TECHNICAL BULLETIN
JTBO0250NAS2
04 MAR 2014

A-Pillar 'Creak' Noise

XJ Range (X351)

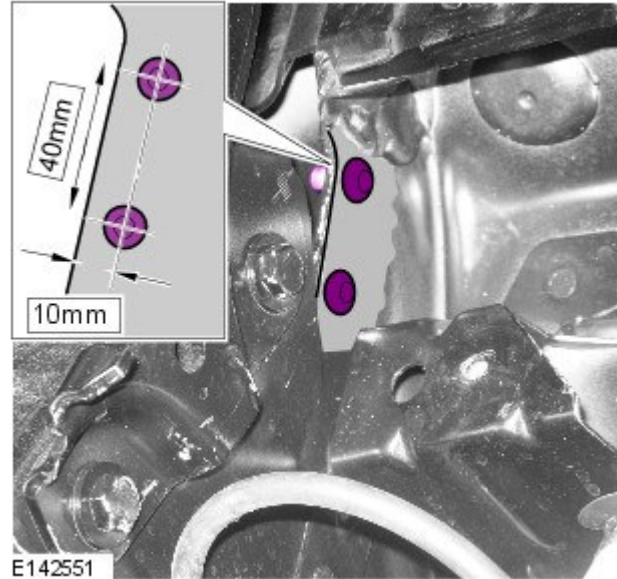
A 'creak' noise from the right-hand (RH) A-pillar may be heard from inside the vehicle.

Cause: This may be caused by the bonded body panels at the seam joint.

1. Remove the Engine Control Module (ECM) for access (see TOPIx Workshop manual, section 303-14).
2. Using suitable tape, tape up the air box to avoid swarf contamination from drilling.
3. Measure 10mm from the panel edge .

- Using a suitable tool, mark the first fixing.
- Measure and mark the second fixing 40mm from the first fixing.

4. Using a suitable 6.5mm drill, drill out the marked fixings.
5. Clean the drilled holes (De burr).
6. Using a suitable sealant, apply sealant to the raw edges of the drilled holes.

Using a suitable rivet gun, install the rivets.

- Using a suitable sealant, apply sealant to the rivets.
8. Remove any swarf from the drilling process.
 9. Remove and discard the masking tape from the air vent.
 10. Install the Engine Control Module (ECM) (see TOPIx Workshop manual, section 303-14).
